Recommendation Proposal

Submittal for November 21, 2016 DRB Meeting

WASHINGTON STATE EMPLOYEES CREDIT UNION (WSECU)
UNIVERSITY DISTRICT

SDCI Project Number: 3022052

a. Strengthen circulation routes & access at ground floor

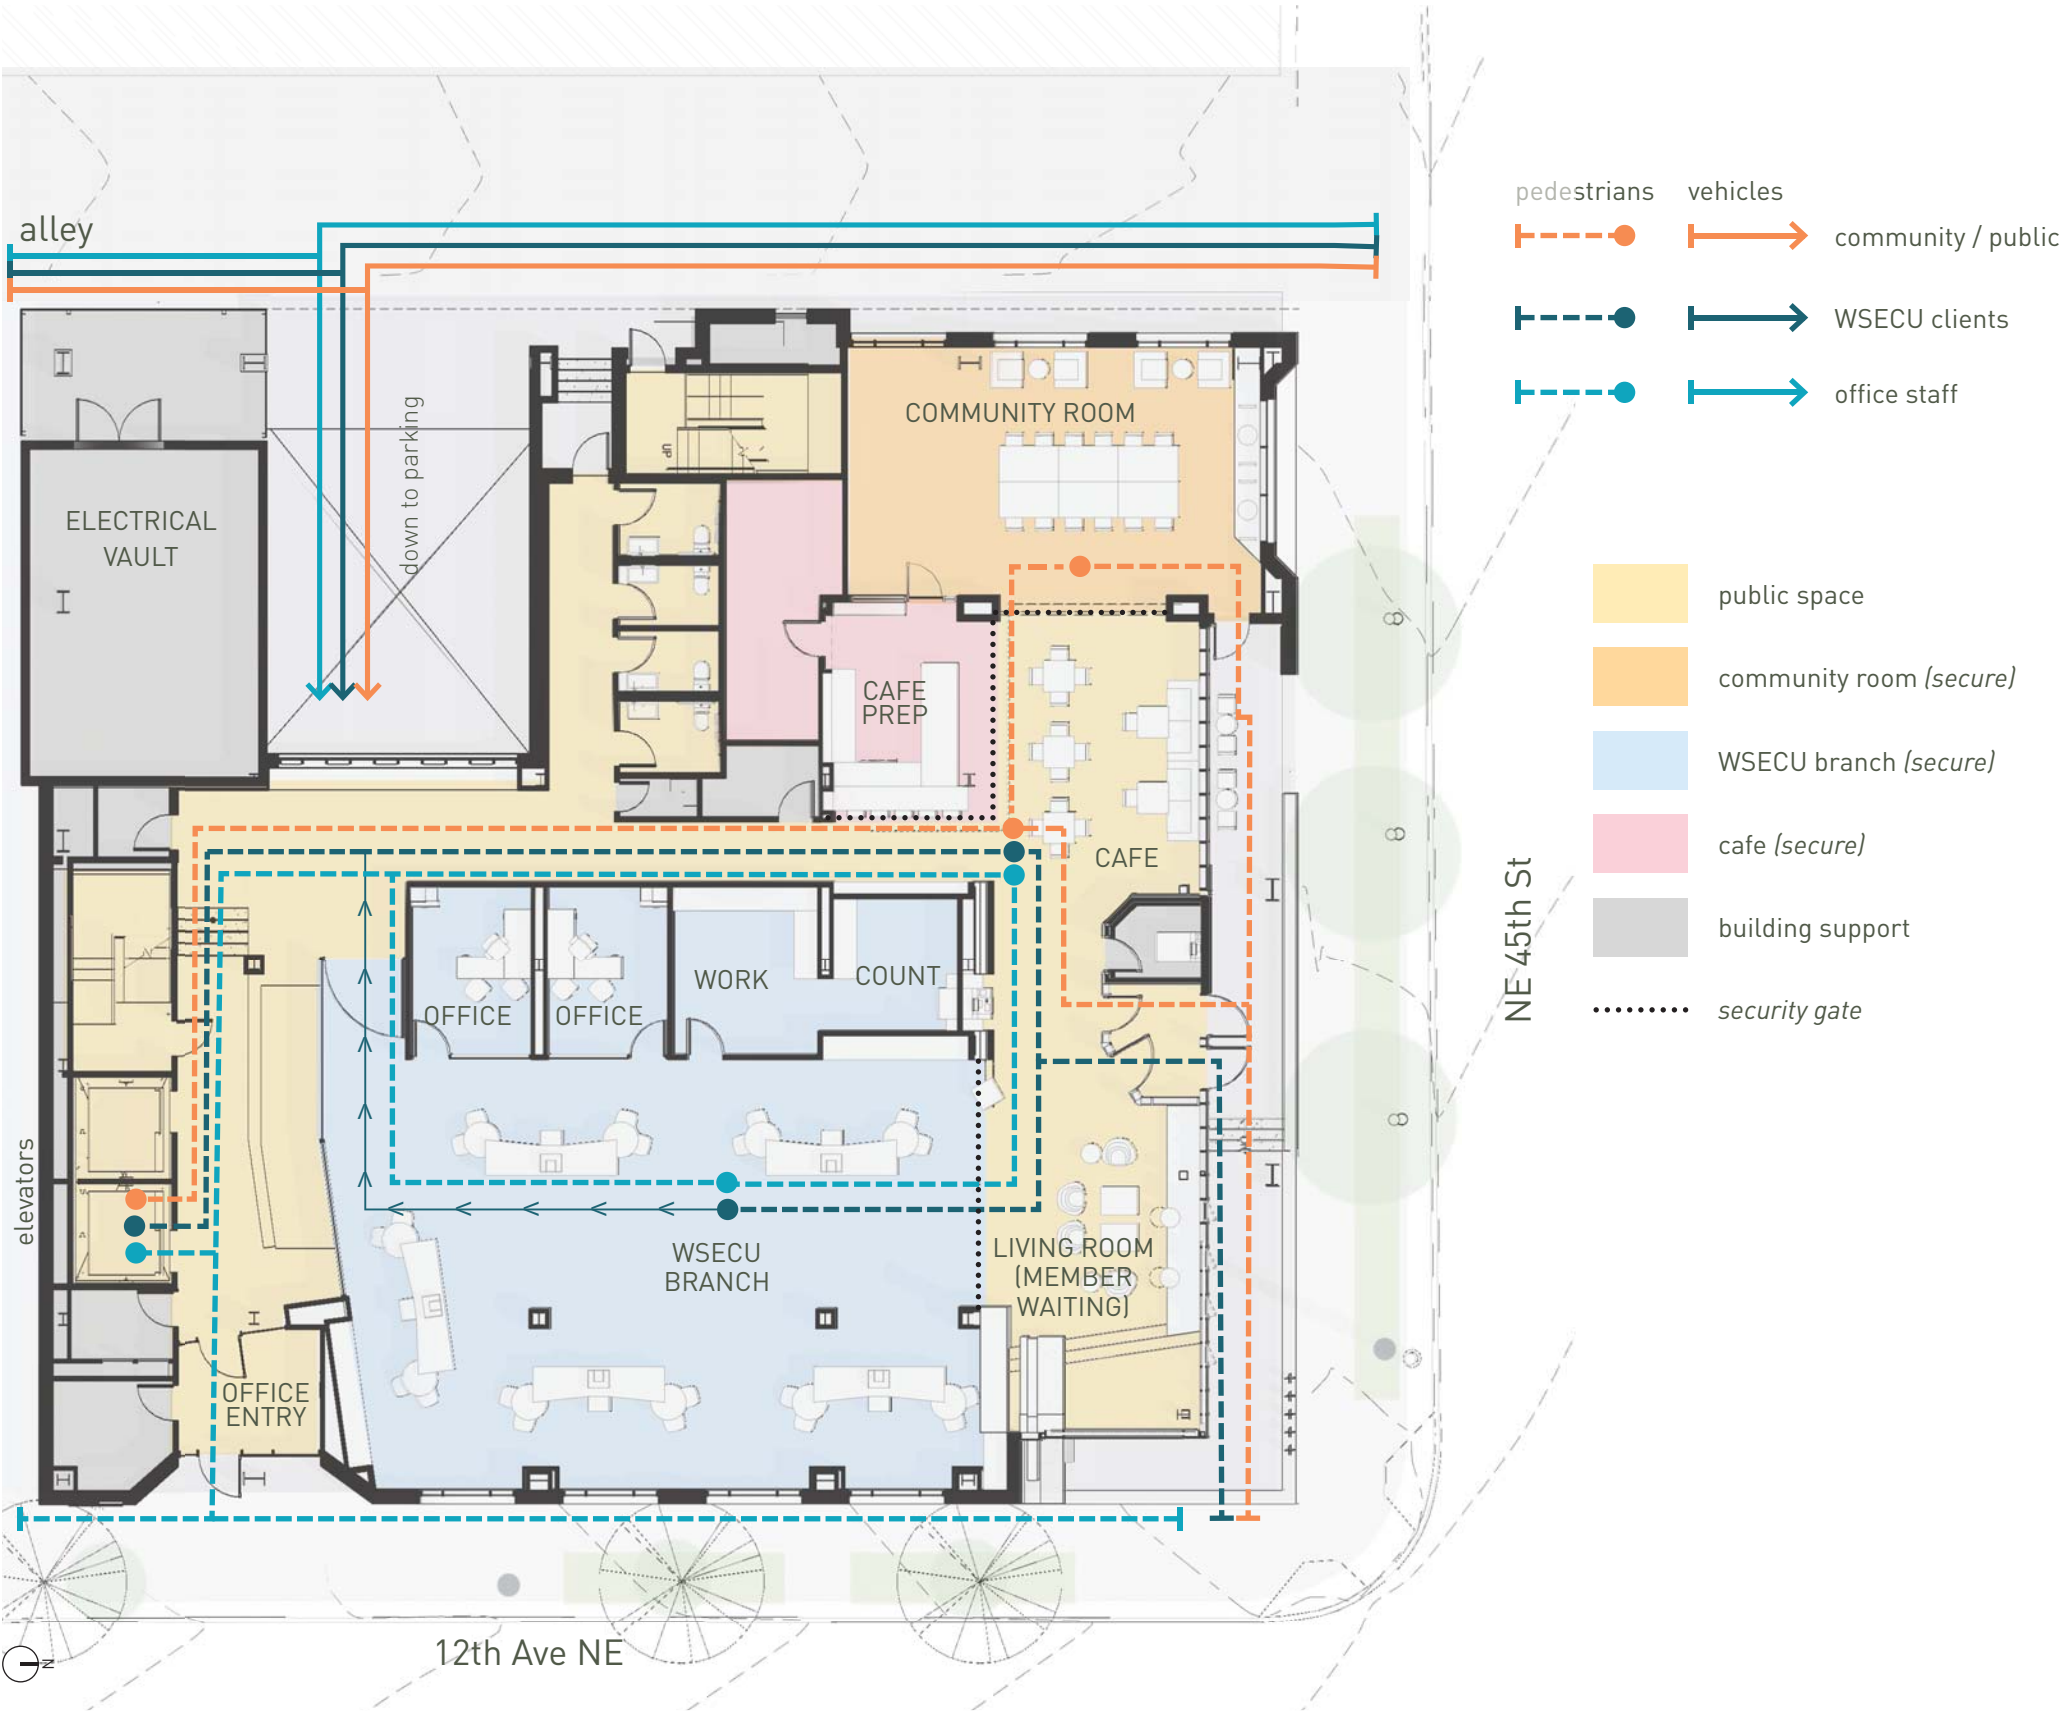
- explore a circulation route which allows access through the lobby for office users
- consider access and connections for the public as related to streetscape connectivity (PL1-B, PL3-A, PL3-I-I, DC1-A)

- study how different users access the building (PL1-B, PL3-A, PL3-I-I, DC1-A)

The primary entrance at 45th St accommodates most of the pedestrian traffic in the area. Office tenant staff now have a dedicated route to the community/cafe area, which is also the route for users who park underground and come up in the elevators. WSECU staff can use the “back door” of the branch retail space to show clients upstairs. While different users will access the building from different points of entry, most of the circulation is centered around the “lobby as living room” along 45th St.

a. Address safety and security

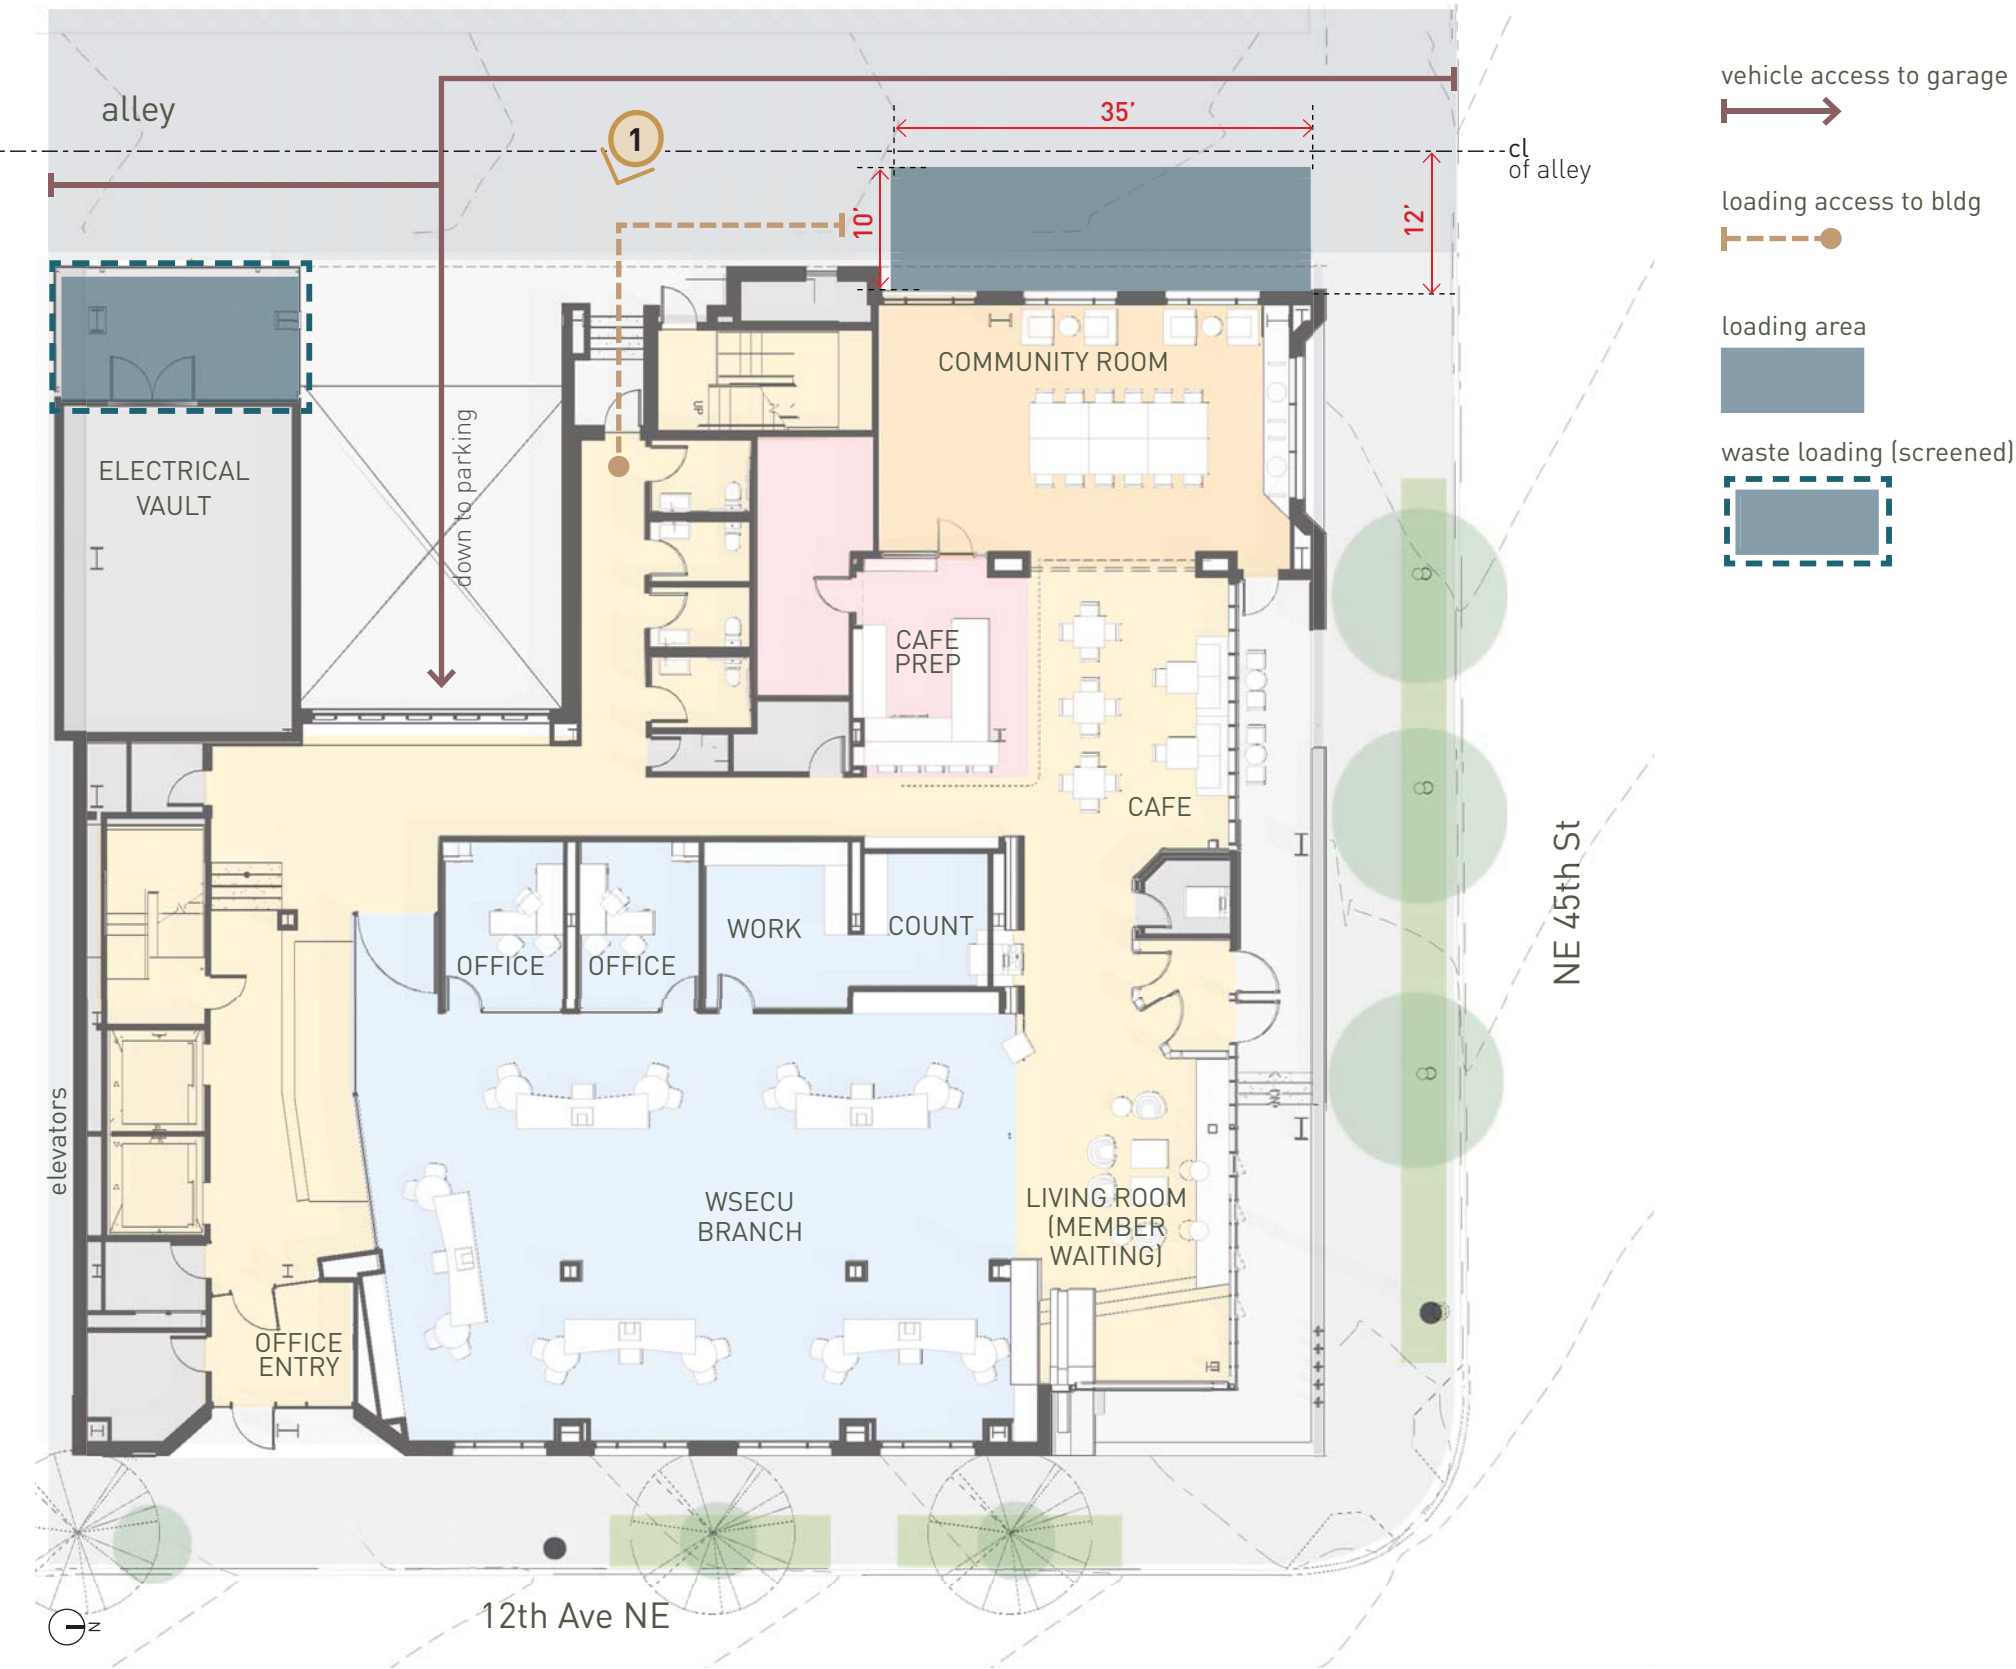
- provide more information about garage storage and loading (service parking access)
- address proximity of alley loading to community room (DC1-B-1)

In response to this comment, the design team has restructured the back-of-house spaces and their adjacencies to the public areas. ADA parking has been moved to the lower level, in accordance with accessibility preferences, and the parking entry is set further back from the street. While the alley will still be the main vehicular access for both parking and loading, all exterior public & employee pedestrian areas have been confined to the North and East sides of the building. Windows along the alley side of the community room provide increased daylight and security. Window blinds allow for room darkening when needed. While loading is located in the same area, it is anticipated to be a relatively infrequent occurrence due to building size.

5. Materials and Detailing

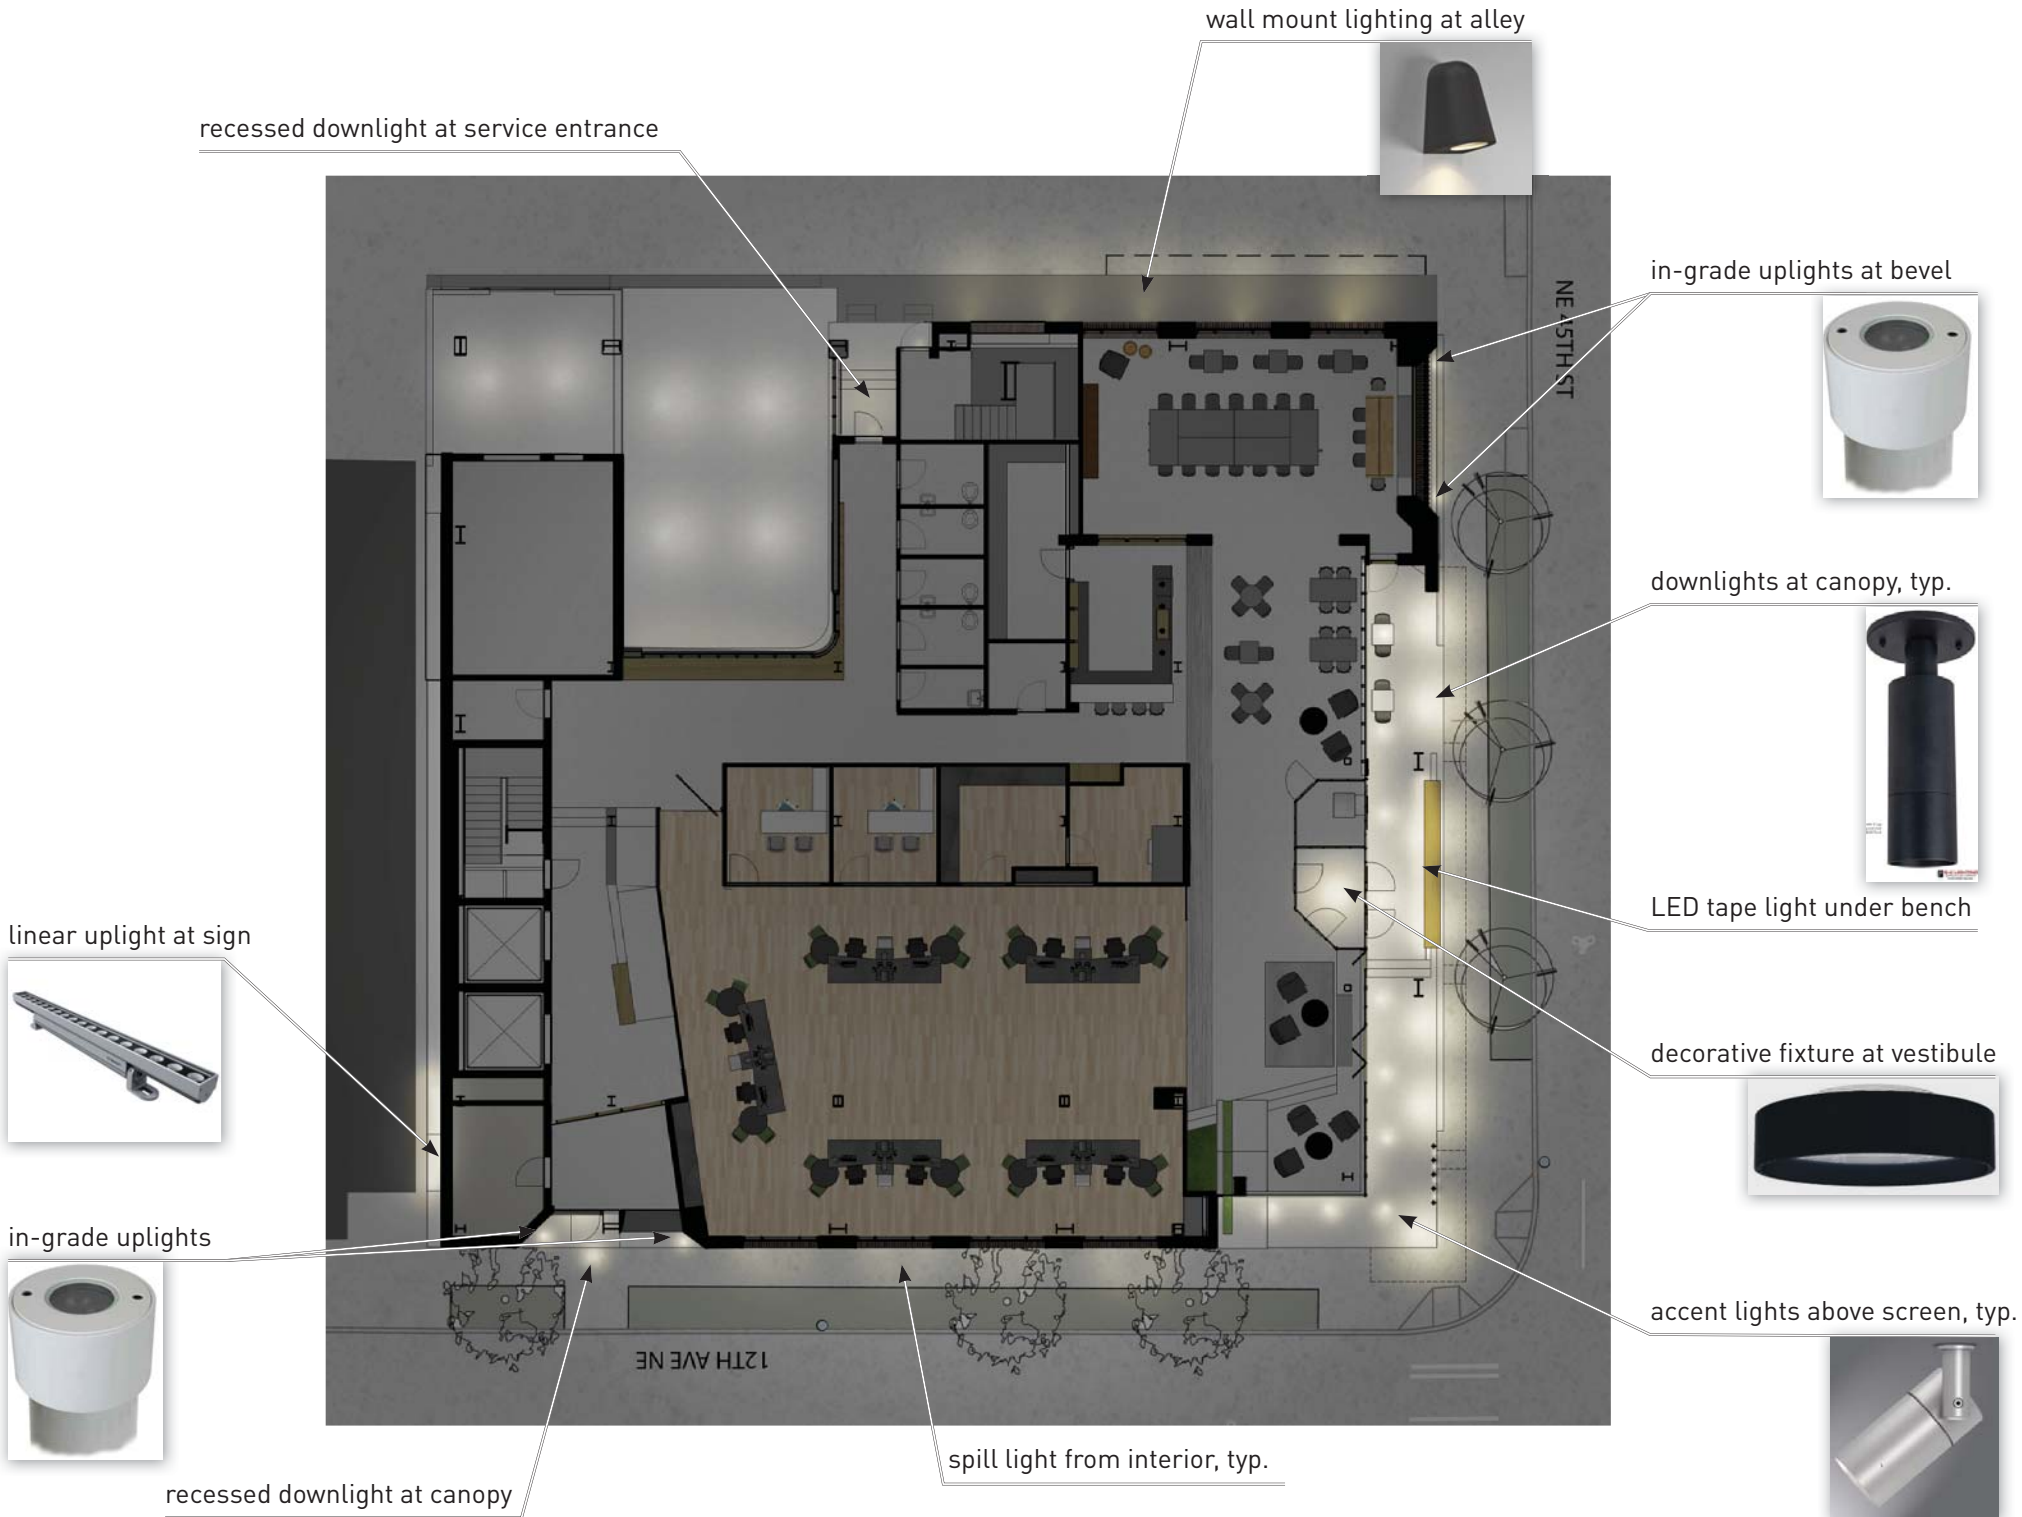
- ✓ **a. Provide brick material as proposed**
 - defines a stately presence which reflects the bank program
(DC2-B, DC2-D, DC4-A)
- ✓ **b. Develop brick detailing**
 - especially important where brick spans the corner opening and where it terminates / meets the sidewalk
(DC2-B, DC2-D, DC4-A)
- ✓ **c. Reinforce/develop the corner expression**
 - retain fluidity of masonry pulled back at corner
 - express the terminus and identify the entry
 - reinforce the contrast between the repetitive glazing mullions and the corner expression
(DC2-B, DC2-D, DC4-A)
- ✓ **d. Coordinate columns, lighting, and signage**
 - complement the project as a whole with coordinated elements
 - provide information about signage
(DC4-B)

The corner expression has been refined while still retaining the original fluid concept. By coupling this gestural move with a change in material, the iconic shape of this corner has been further defined. The precast concrete “ribbon” runs above the entry plaza, terminating at the secondary entrance to the community room. The main building entrance is further emphasized with the use of a screen element and exterior lighting. The fenestration pattern of the primary building mass is intended to maintain the integrity of the “box” form. The punched windows are double story and staggered to de-emphasize the floor lines and resultant horizontal “banding”. They are also recessed and lined with a contrasting brick color to distinguish them from the field.

The detailing of the brick has been developed to emphasize aspects of the building design. Beveled openings with woven brick patterns denote building entries and nooks where the public space carves into the building skin. Soldier coursing above and below punched windows reinforces the pattern of the window placement and provides additional interest at ground level. The brick transitions cleanly to concrete at the sidewalk, allowing the building to be viewed as a separate object. The brick at the iconic corner is rounded -- a unique condition for this project -- further emphasizing the fluidity of the corner expression.
